**TECHNICAL BULLETIN  
No. 0118**

**New OK TO PUMP  
THROTTLE READY Panel Plate**

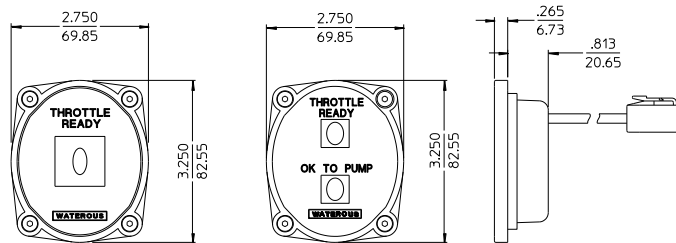
Orders received after June 1, 2016 will have the new Dual Light OK TO PUMP / THROTTLE READY Panel Plate (P/N 63805) which replaces the Single Light THROTTLE READY Panel Plate (P/N 63334).

This change is due to the NFPA 1901,2016 Edition, Section 16.10.2.1.2.

The figure below shows both the Single Light and Dual Light. Both panels use the same panel cut-out dimensions but have different wiring as shown on page two.
